Bill No. 01R-221

**TITLE: PRELIMINARY PLAT NO. 00017, STONE BRIDGE CREEK**, requested by Hampton Development Services, for 315 single family lots, 80 attached single family lots, 1 multi-family lot, 7 outlots, 2 industrial lots and 2 large lots for potential future urban village, with associated waiver requests, on property generally located between North 14<sup>th</sup> and North 27<sup>th</sup> Streets, north of I-80 and south of Alvo and Arbor Roads.

Re: Preliminary Plat No. 00017  
Stone Bridge Creek

**P.A.S.:** Stone Bridge Creek  
Annexation No. 00003  
Change of Zone # 3265  
Special Permit # 1845  
Preliminary Plat #00017  
Use Permit # 139

STONE BRIDGE CREEK  
SITE PLAN

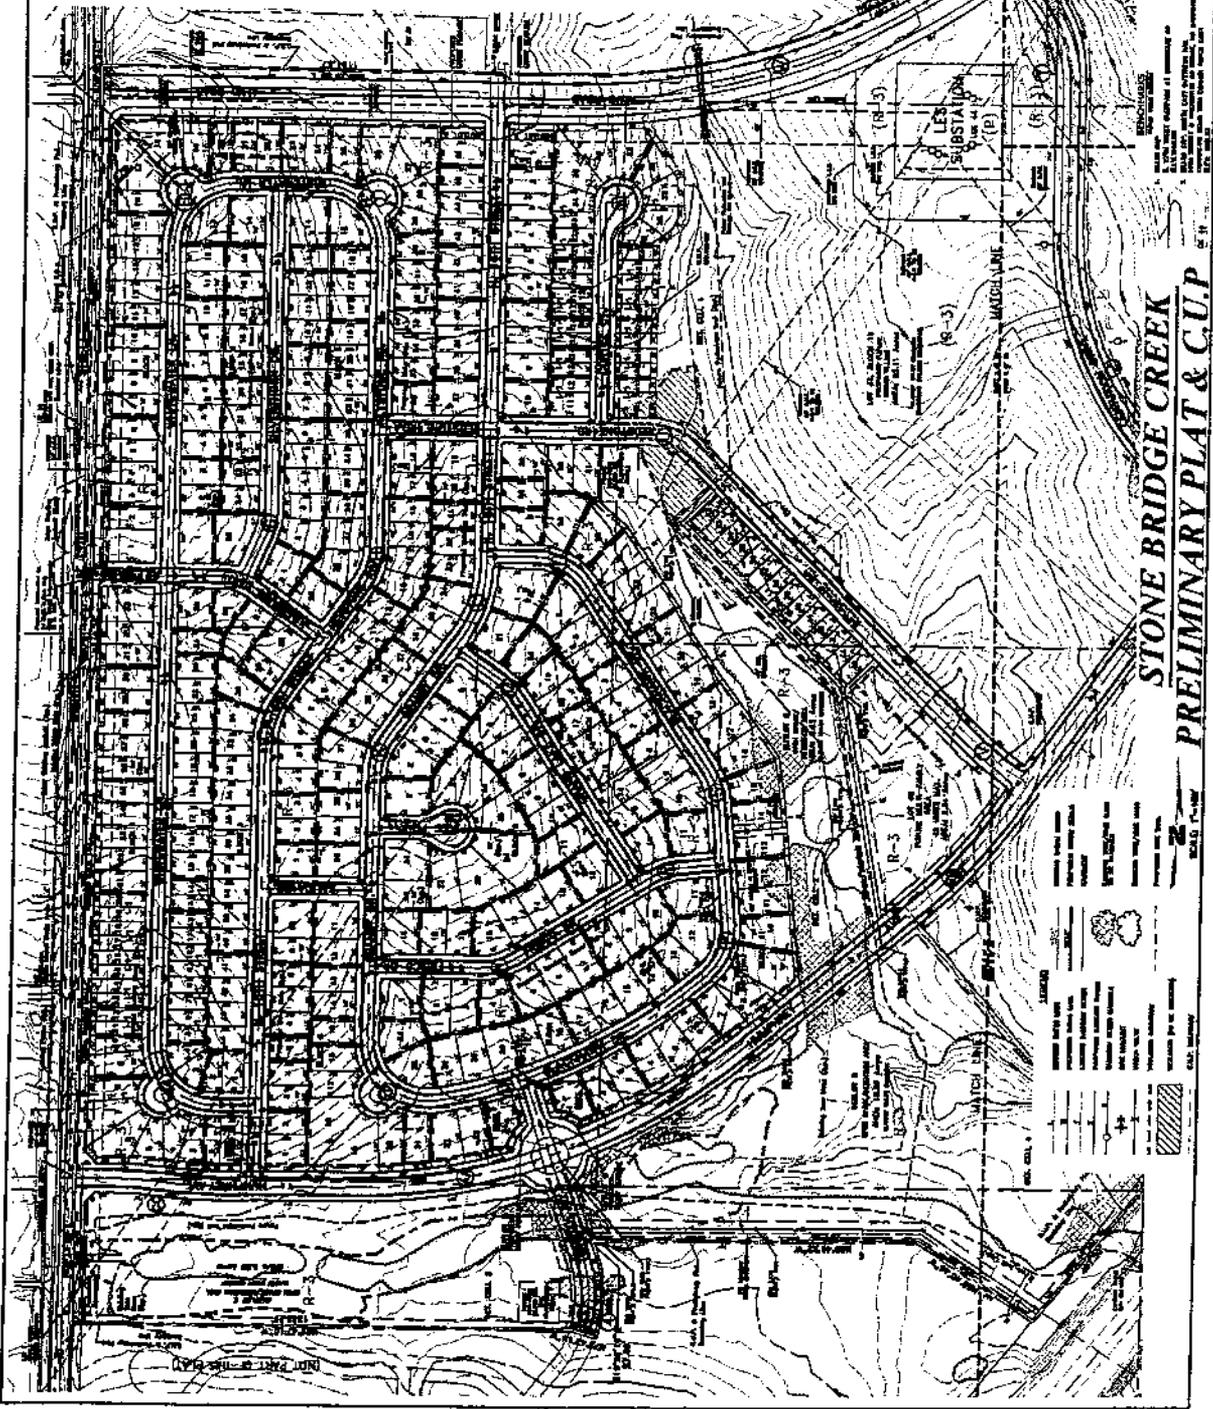
- 1.1.4 Different street names than Pikes Peak and Granby as they are too close to existing names.
    - 1.1.5 Grading and drainage plans to meet design standards and to the satisfaction to the Public Works Department; however, in areas where natural drainage ways are used to create storm water detention, the minimum 2% slope through the detention area and low flow liner requirement shall be waived. A note shall be added to the preliminary plat indicating that erosion control shall be a specific item of maintenance required for all outlots. (\*\*As revised by Planning Commission at the request of the applicant, 7/11/01\*\*)

- 1.1.8 Pedestrian easements that meet the development standards of the Land Subdivision Ordinance in Blocks 2, 3, 5 and 7. **(\*\*As revised by staff and approved by Planning Commission, 7/11/01\*\*)**

- 1.1.9 A pedestrian easement and 4' sidewalk between lots 13 & 14, Block 11 that extends the sidewalk and easement to the future pedestrian trail; however, the portion of the easement and sidewalk in an Outlot C shall be located, dedicated and constructed at the time of construction of the bike trail. **(\*\*As revised by Planning Commission at the request of the applicant, 7/11/01\*\*)**

- 1.1.11 Keystone Road renamed to N. 15<sup>th</sup> Street, Granby Road renamed to N. 16<sup>th</sup> Street and Cortez Court to N. 17<sup>th</sup> Court.

7. The storm water design standards require 2% slope through detention areas. Standards also require a low flow liner, pilot channel, or other means to control erosion along the channel. Information is needed to show how these requirements are met or why they cannot be met. Public Works recommends the waiver concerning the channel bottom protection be denied. The development along the channel adds runoff to the channel and will change its natural character. Waiving these requirements will cause future problems.

9. Public Works continues to recommend that the full intersection with Alvo-Arbor Road be moved from North 16<sup>th</sup> Street to Cortez Court to meet design standards. The required ¼ mile spacing of median openings provides more efficient operation of Alvo-Arbor in the event that future signalization is needed for this intersection. While the impact study does not indicate that it is necessary, unforeseen future land uses and traffic conditions may warrant it.

11. The Emergency Communications Department continues to strongly recommend that Keystone Road be renamed because it is too similar to another street name. Furthermore, Keystone Road should be renamed to N. 15<sup>th</sup> Street because it is a north-south road.
